Check of the prototype design for 2021 beam test @ SPS

Eugenio Berti, Raffaello D'Alessandro, Sebastiano Detti, Lorenzo Pacini, Oleksandr Starodubtsev,
for the Firenze INFN HERD group.

Cable position: current design

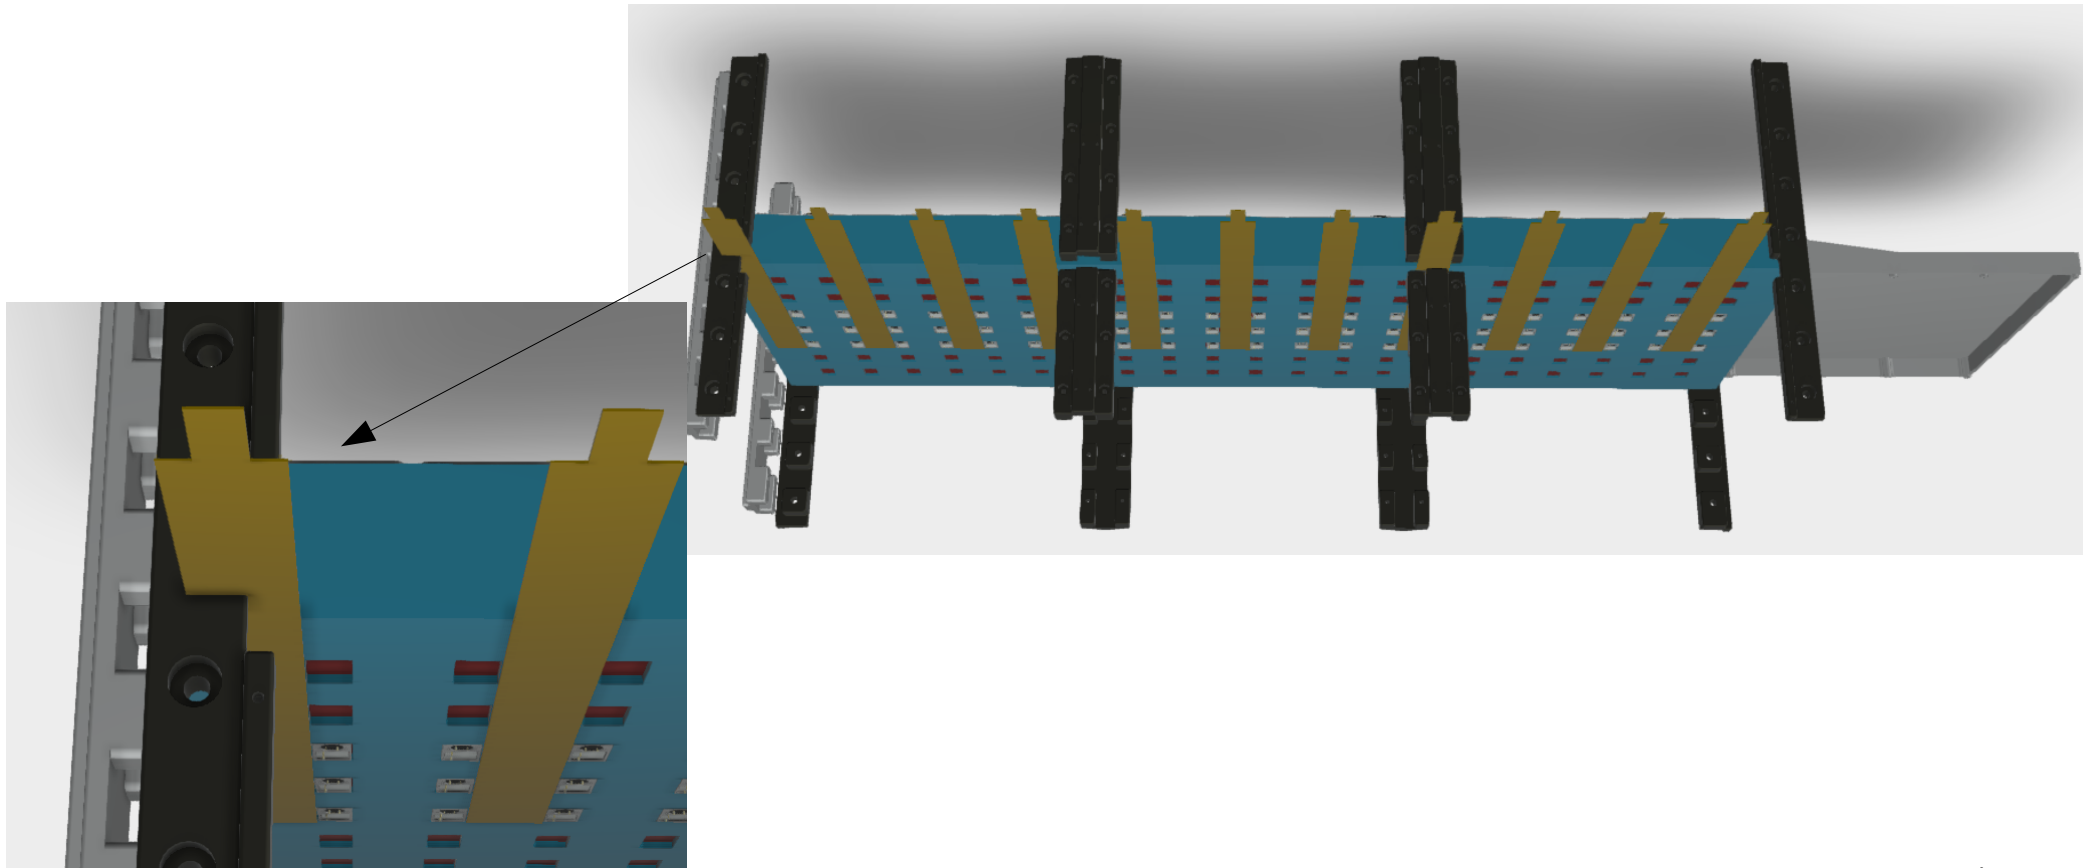
In this design the first cable hits a mechanical structure:

Cable position: proposal

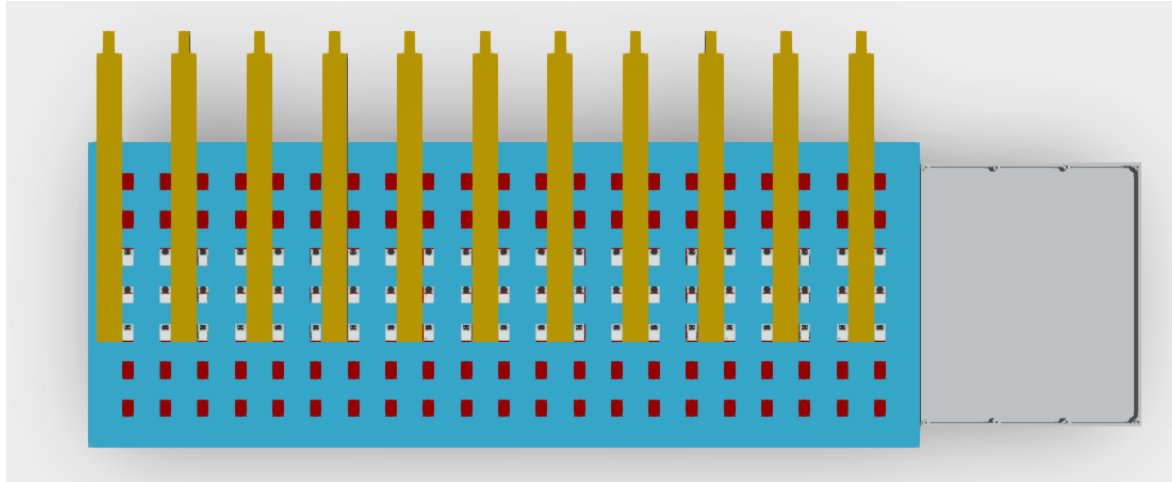
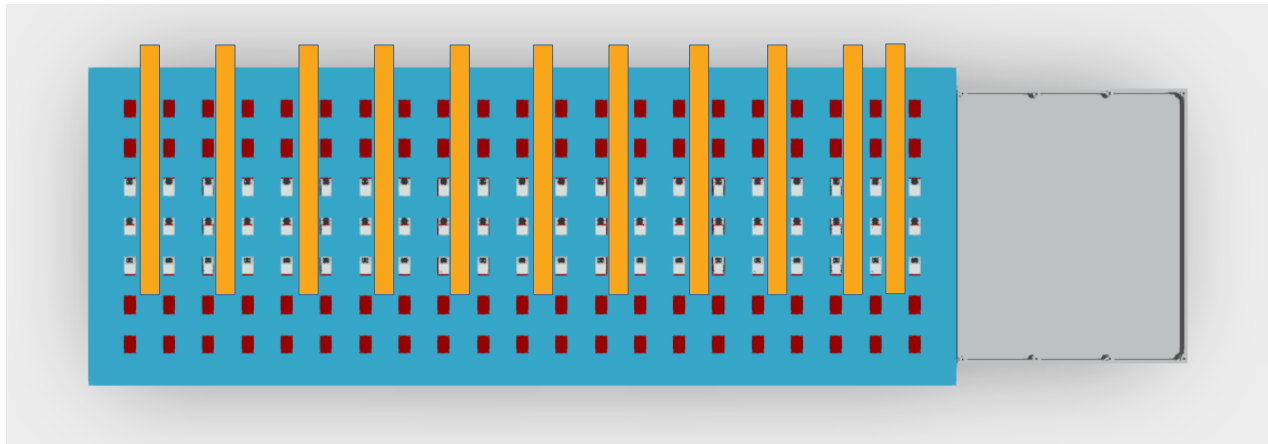
Our proposal: shift the position of the cables on the left, excluding the last one:

**This is a
simplified
picture, the
CAD file must
be updated**

This update has
not impact on
the current
mechanical
structure

Front-end board: adjusted direction

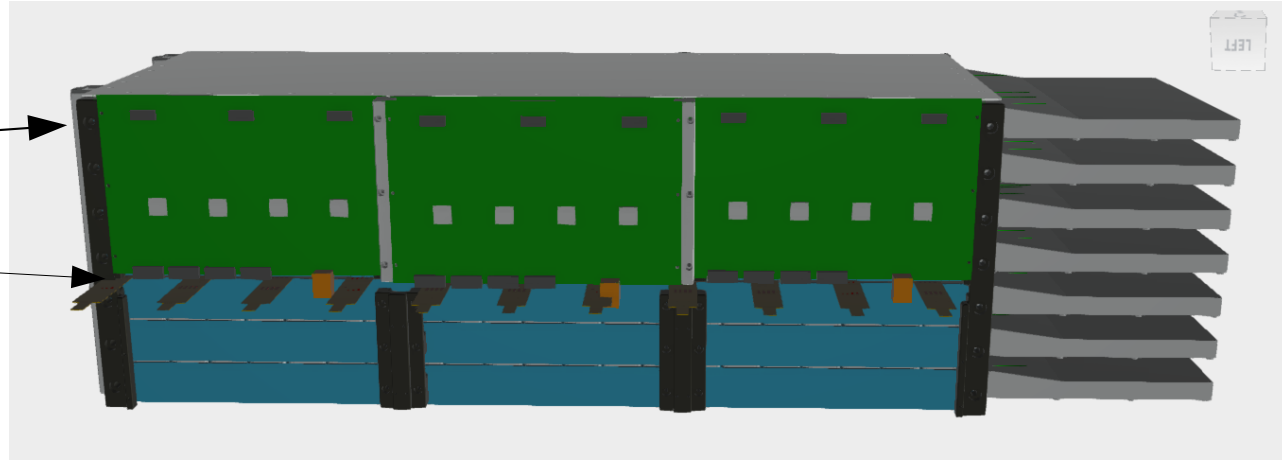
Boards must be rotated by 180 degrees:

Connectors to TROC2

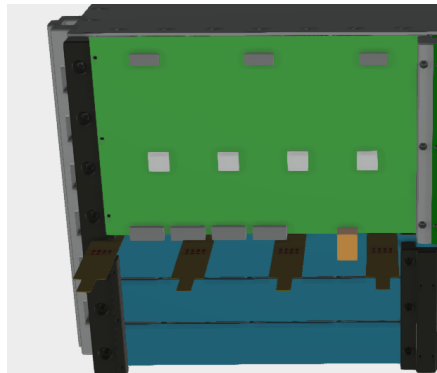
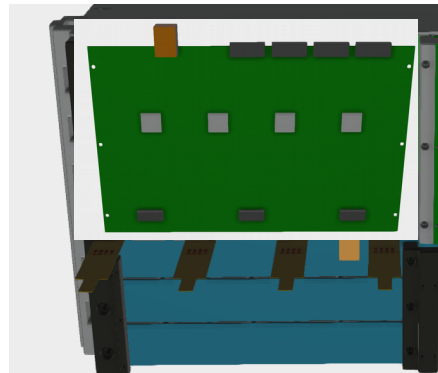
Now

To be done

This update has not impact on the mechanical structure

Kapton cables - FFE connections

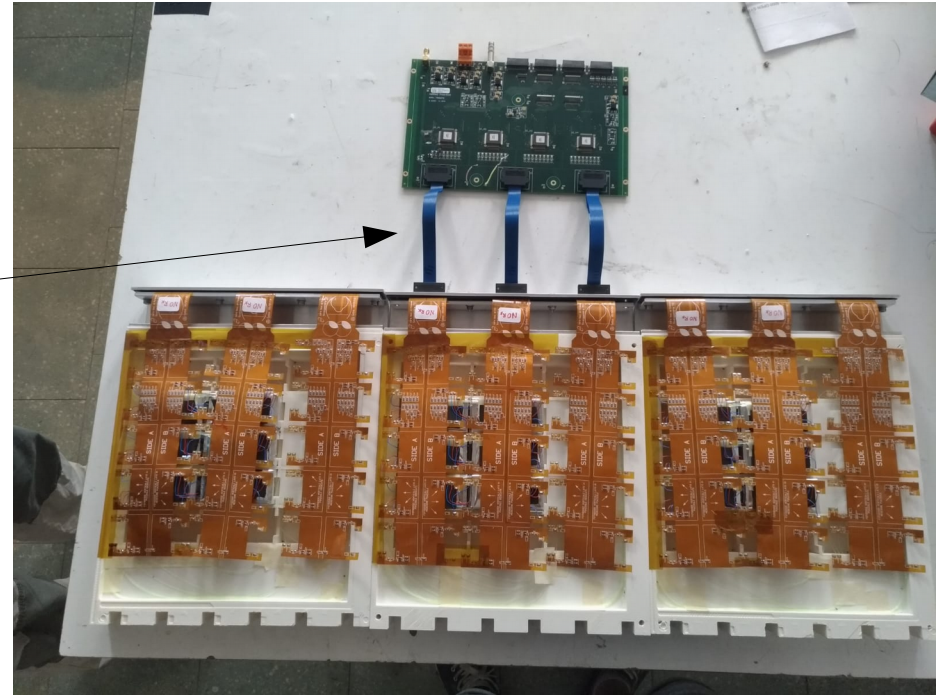
The kapton cables are not directly connected to the front-end: the FFE connectors are not aligned with the kapton cables since the board are designed for Csl prototype.

Samtec flex cables are used: it allow some distance between the cable connectors and the board connectors.

The length of the flex cable should be checked after the update of the prototype CAD design.

Samtec flex cable with proper length will be provided to IHEP with the Kapton cables.

TROC1 and TROC2: proposal

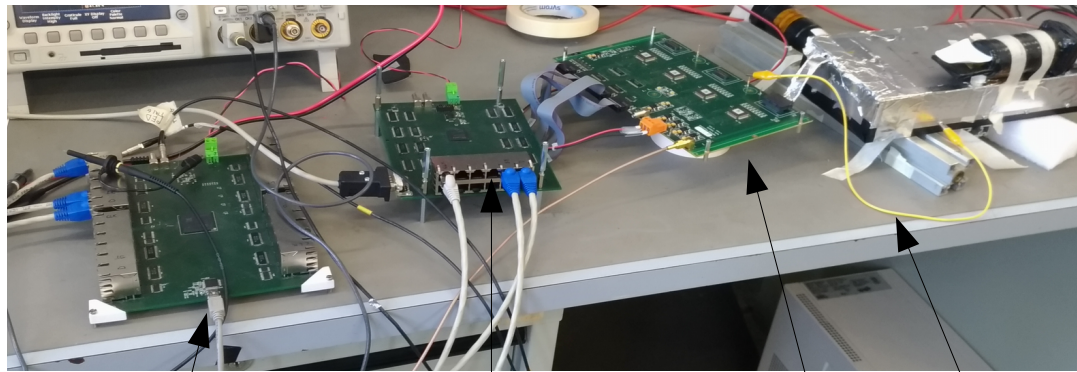
TROC1 could be placed outside the big box used to black the light.

TROC1-TROC2 link can be done with long cables.

TROC2 (1 or 2 boards, to be determined) could be placed on the TOP of the calo.

TROC2-FFE are done with short cables.

Small hole required in the covering box for TROC1 cable

Some simple structure (4 small columns) needed for TROC2 on the top of the Calo
